-----  
ADDRESS : 214 SADDLE LN SUBDIV: JOHNSON FARMS 34 LOTS  
CONTRACTOR : SIGNATURE HOME BUILDERS PHONE : (910) 892-9299  
OWNER : INVESTMENT CHOICES LLC PHONE :  
PARCEL : 11-0661- - -0100- -14-  
APPL NUMBER: 17-50041008 CP NEW RESIDENTIAL (SFD)  
DIRECTIONS : T/S: 03/22/2017 03:41 PM DJOHNSON --  
JOHNSON FARMS LOT 14  
\*\*\*\*\*PREMISE NO 26719840\*\*\*\*\*  
T/S: 03/24/2017 09:08 AM DJOHNSON --  
-----

Re: J0417-1872  
Lot 14 Johnson Farms

*Floor Truss Repair Letter*

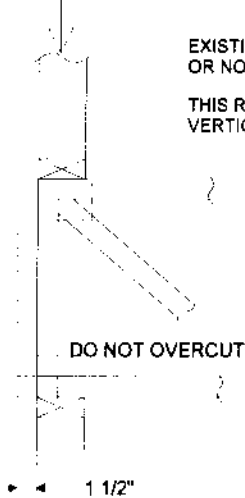
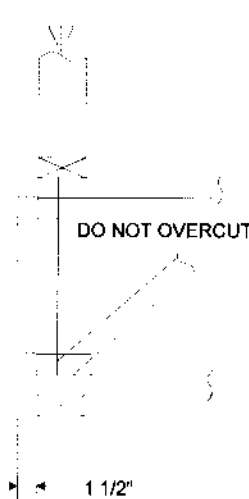
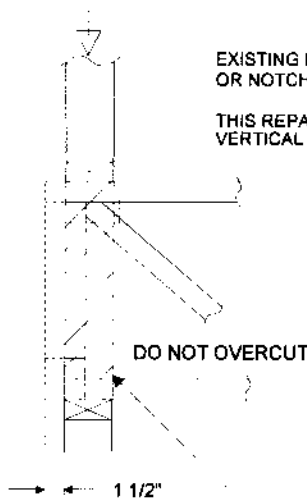
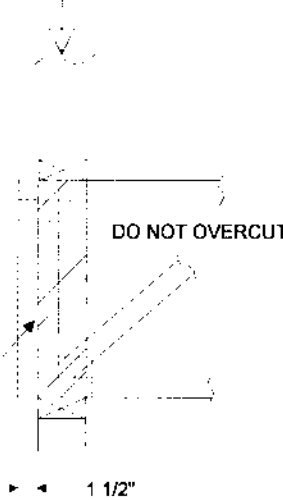
1. THIS IS A SPECIFIC REPAIR DETAIL TO BE USED ONLY FOR ITS ORIGINAL INTENTION. THIS REPAIR DOES NOT IMPLY THAT THE REMAINING PORTION OF THE TRUSS IS UNDAMAGED. THE ENTIRE TRUSS SHALL BE INSPECTED TO VERIFY THAT NO FURTHER REPAIRS ARE REQUIRED.
2. ALL MEMBERS MUST BE RETURNED TO THEIR ORIGINAL POSITIONS BEFORE APPLYING REPAIR AND HELD IN PLACE DURING APPLICATION OF REPAIR.
3. THE END DISTANCE, EDGE DISTANCE, AND SPACING OF NAILS SHALL BE SUCH AS TO AVOID SPLITTING OF THE WOOD.
4. LUMBER MUST BE CUT CLEANLY AND ACCURATELY AND THE REMAINING WOOD MUST BE UNDAMAGED.
5. THIS REPAIR SHALL BE USED FOR SINGLE PLY TRUSSES IN THE 4X2 ORIENTATION ONLY.
6. CONNECTOR PLATES MUST BE FULLY IMBEDDED AND UNDISTURBED.

500# MAXIMUM WALL LOAD FROM ABOVE

EXISTING END VERTICAL MAY BE FULL DEPTH OR NOTCHED FOR RIBBON BOARD.  
 THIS REPAIR MAY REMOVE ENTIRE END VERTICAL OR NOTCH IT FOR A RIBBON BOARD.

500# MAXIMUM WALL LOAD FROM ABOVE

4000# MAXIMUM WALL LOAD FROM ABOVE

EXISTING END VERTICAL MAY BE FULL DEPTH OR NOTCHED FOR RIBBON BOARD.  
 THIS REPAIR MAY REMOVE ENTIRE END VERTICAL OR NOTCH IT FOR A RIBBON BOARD.

4000# MAXIMUM WALL LOAD FROM ABOVE
